13. Nature Conservation - Marine

Submissions have criticised the EIS for excluding information relating to the significance of the marine environment surrounding HHI.

Figure 13-1 Relative dugong density and conservation value on the east coast of Australia based on the model of Grech & Marsh 2007. Source: H. Marsh pers comm. 5/8/08

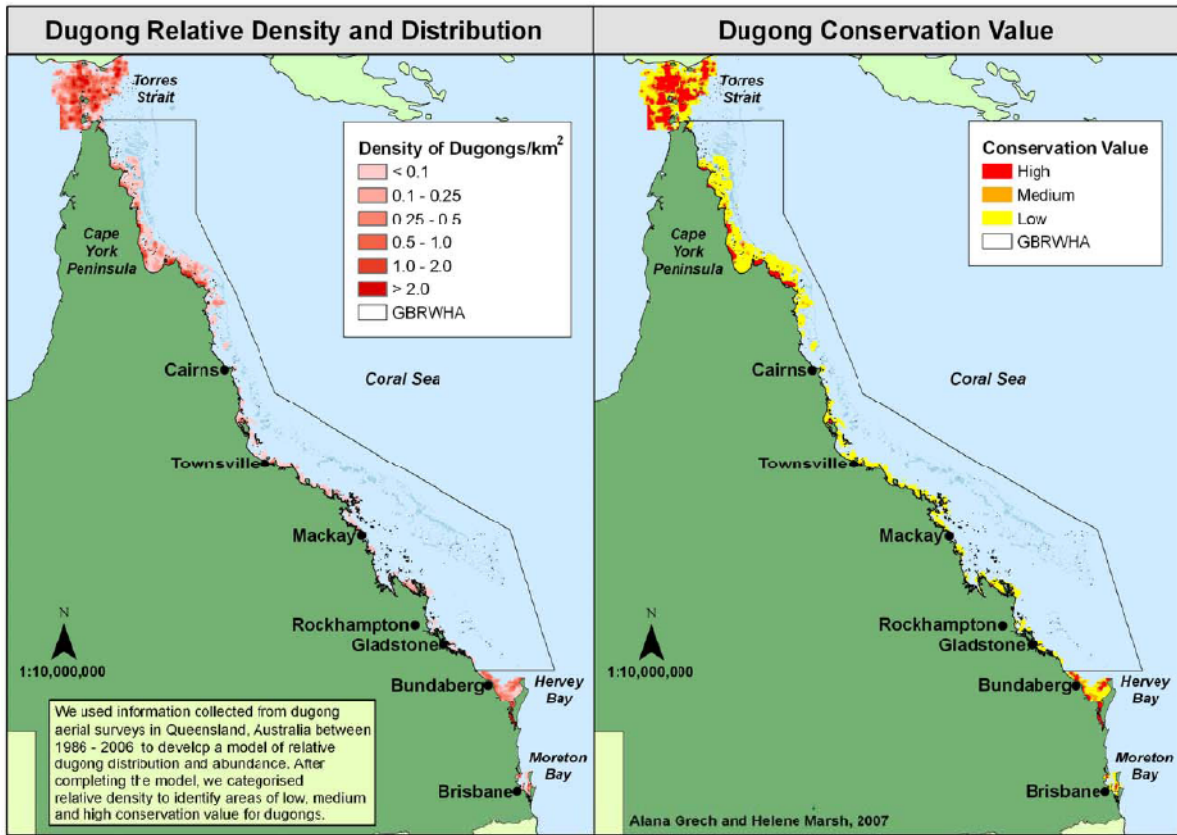
Submissions raised the issue of potential impacts on dugongs due to boat strike. In addition to mortality and injury from direct boat strike, there is the potential for sub-lethal effects on dugong health, survival, and reproductive success from boat disturbance, including by boat noise, for example by disruption of feeding behaviour, increased energy expenditure (for example by inducing flight reactions), or displacement of dugongs from preferred feeding grounds.

Professor Helene Marsh (pers. comm., 5/8/08) indicates that the spatially explicit population model of Grech & Marsh (2007), which incorporated the results of aerial population surveys, is a better indicator of the relative importance of Rodds Bay as a dugong habitat than the “snapshot” estimates made in individual aerial surveys. The model indicates that dugong density and relative dugong conservation value is low in the area immediately surrounding Hummock Hill Island, relative to other areas in Queensland (Figure 13-1). Model output obtained specifically for the area around Hummock Hill Island (A. Grech, person comm., 6/8/08) indicates that dugongs are likely to occur in most parts of Rodds Bay, and more likely on the eastern side, but again that the dugong population is low relative to other areas of Queensland (Figure 13-2). The modelled relative density of dugongs throughout Rodds Bay DPA is $<0.15/\text{km}^2$, and on the western side of Hummock Hill Island mostly $<0.04/\text{km}^2$. This indicates that the Rodds Bay DPA has a low conservation value relative to Shoalwater Bay, Great Sandy Strait, and Moreton Bay, where modelled densities can exceed $1.0/\text{km}^2$. Note that the density values shown in Figure 13-1 and Figure 13-2 should not be interpreted as actual abundance in number of individuals/ km^2 , but as a probability of occurrence. Thus, a grid cell with a value of 1.0 is likely to have ten times as many dugongs as a cell with a value of 0.1.

Marsh & Corkeron (1997) estimated that human-caused mortality of more than 1-2% of the female dugong population per year is unsustainable. More recently, Marsh & Lawler (2006) recommended that for the entire dugong population south of Cooktown, mortality from all human causes should be kept below about 40 individuals per year. They estimated the total size of this population at 5172 individuals, so human-induced mortality should be kept below about 0.77 per 100 individuals per year. Ignoring the likely connectivity of the Rodds Bay dugong population with the larger populations to the north and south, the sustainability of even a single female mortality per year from boat strike is therefore questionable. Even though the model of Grech & Marsh (2007) indicates that the Rodds Bay DPA has a low dugong conservation value relative to Shoalwater Bay, Hervey Bay, Great Sandy Strait and Moreton Bay, dugong mortality from boat strike should be kept as close to zero as possible.

The frequency of boat strikes of dugongs in relation to total vessel use is unknown. Based on total recreational vessel registrations of 179,231 in 2003, and the occurrence of 2-7 boat strike incidents per year from 1998 to 2006 (Greenland & Limpus, 2007), boat strike incidents for Queensland as a whole are rare. More relevant to the area around HHI, some 6,324 private vessels were registered in the Gladstone, Miriam Vale and Calliope shires in 2006 (EIS Table 9.10). DERM (previously EPA) marine wildlife stranding and mortality database annual reports record one boat strike mortality, in 2002, during the period 1998 - 2006 from or within 10 km of the Rodds Bay DPA.

This indicates an average boat-strike mortality of about 0.02 per 1,000 boats per year. It is recognised that an unknown number of dugong mortalities from boat strike may go unreported or be ascribed to "unknown cause", but based on known boat strike mortality the increase in vessel numbers resulting from the development can be expected to result in considerably less than 1 additional dugong mortality annually.

Figure 13-3 Stormwater Flow Headland Zone

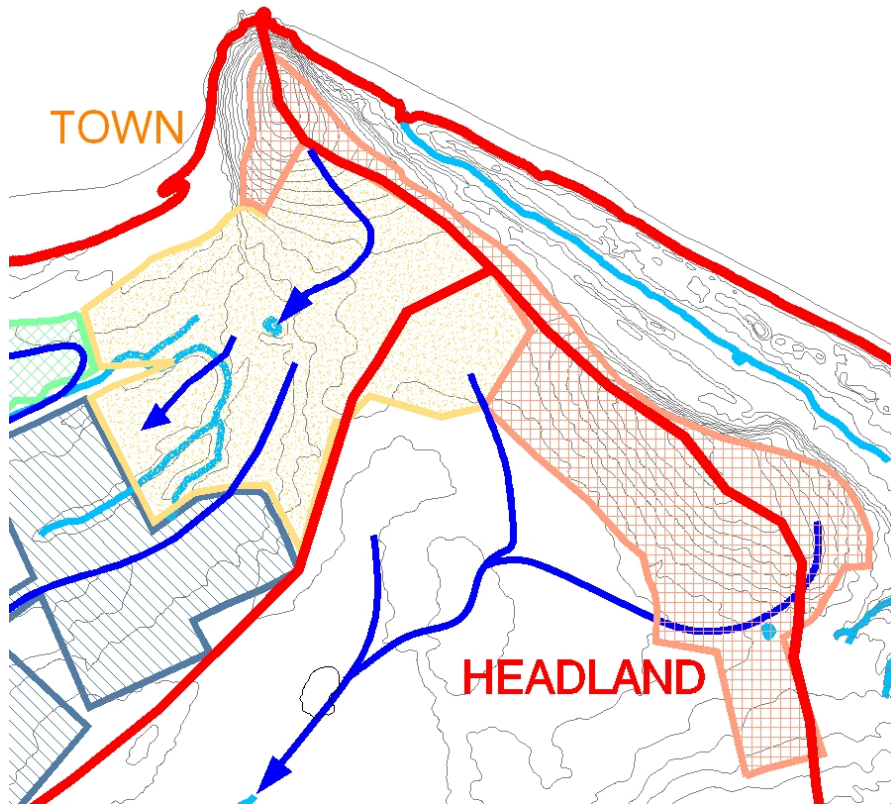
Submissions expressed concern about potential impacts of land-based pollution on coral communities.

The conceptual stormwater management plan in Appendix A7.2 of the EIS provides for stormwater flows from the Town zone, and possibly from the northern part of the Headland zone, to North Beach via bioretention and detention ponds and an existing depression. In light of the presence of the coral communities approximately 1.3 km to the east on the other side of the Northern Headland, all stormwater flows from the Town and Headland zones will be directed to the south, with no discharge at North Beach south of the Northern Headland.

As discussed below in Section 13-10, mitigation measures including Erosion and Sediment Control Plans (ESCP), Water Sensitive Urban Design (WSUD), integrated turf and pest management, the maintenance of a 100 m development buffer from Highest Astronomical Tide (HAT), and the elimination of septic tanks and discharges of treated sewage or desalination effluents to the marine environment are designed to prevent impacts on water quality, and an approved water quality monitoring plan will be implemented to monitor the effectiveness of these measures.
